**CCB 7199**

**Pre and Post Change Summary**

**PCN #: DSNO-18DVZK566**

# Frame Comparison – 14L SSI (Bottom Frame Width)

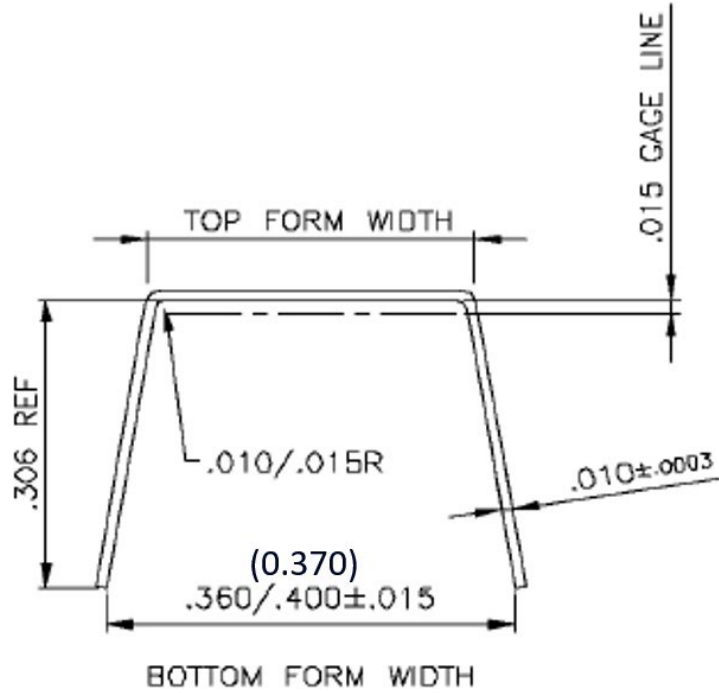
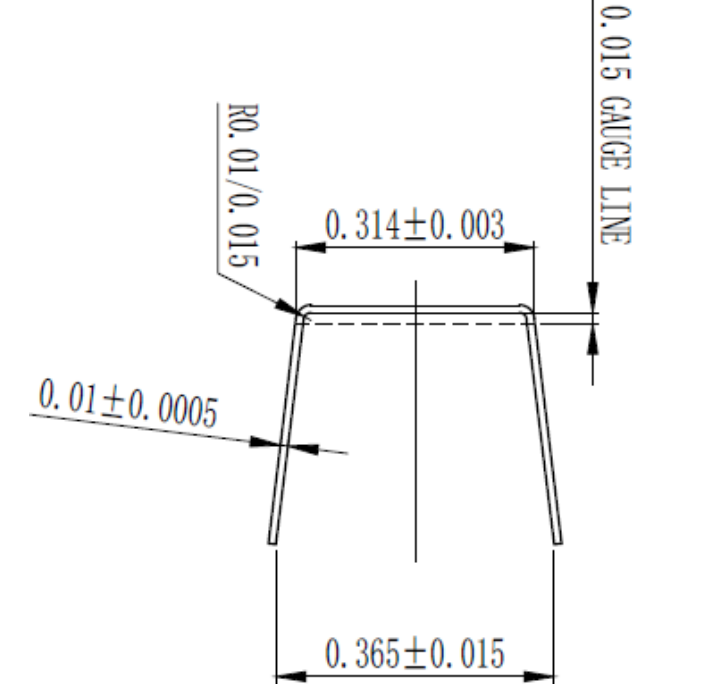
Pre Change	Post Change				
 <table border="1" data-bbox="377 1062 1128 1210"> <tr> <th>Bottom Frame Width Dimension</th> </tr> <tr> <td>0.370 inch</td> </tr> </table>	Bottom Frame Width Dimension	0.370 inch	 <table border="1" data-bbox="1454 1062 2206 1210"> <tr> <th>Bottom Frame Width Dimension</th> </tr> <tr> <td>0.365 inch</td> </tr> </table>	Bottom Frame Width Dimension	0.365 inch
Bottom Frame Width Dimension					
0.370 inch					
Bottom Frame Width Dimension					
0.365 inch

# Frame Comparison – 16L LSI (Frame Cavity Dimension)

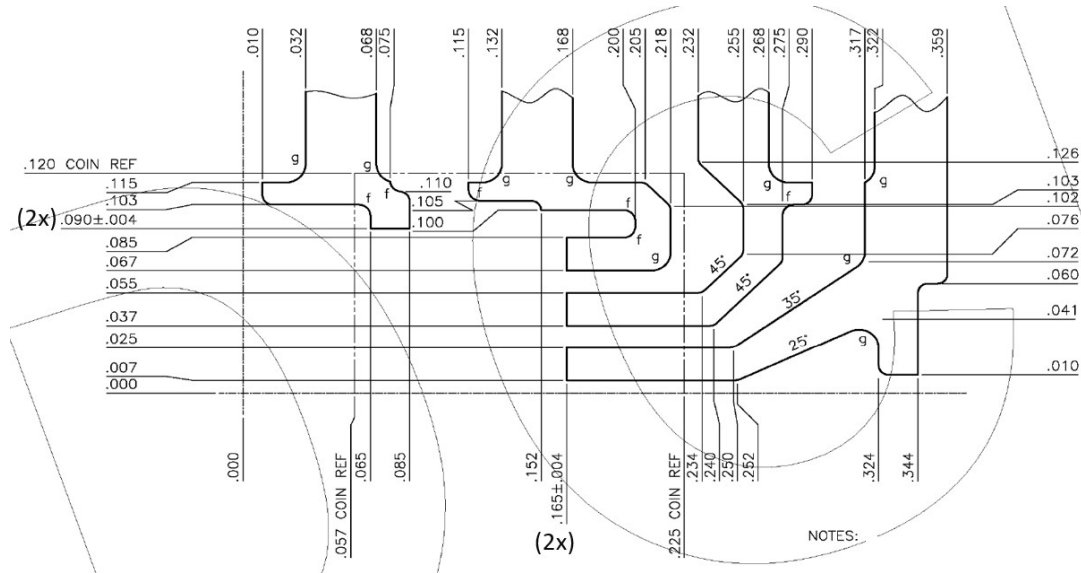
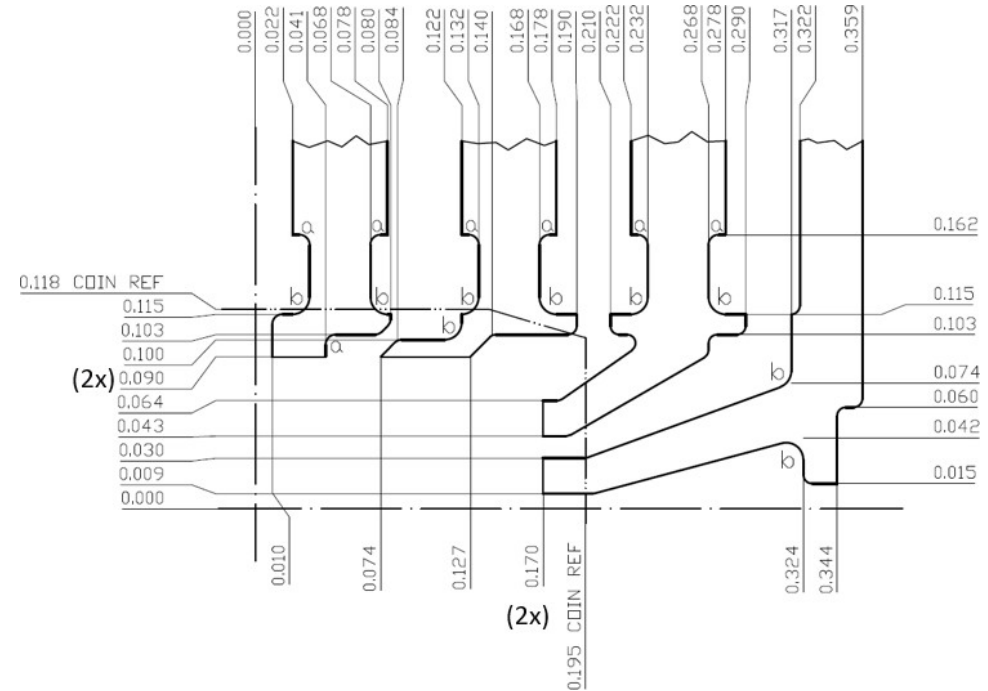
## Pre Change

**Frame Cavity Dimension**

**0.330 x 0.180 inch**

## Post Change

**Frame Cavity Dimension**

**0.340 x 0.180 inch**
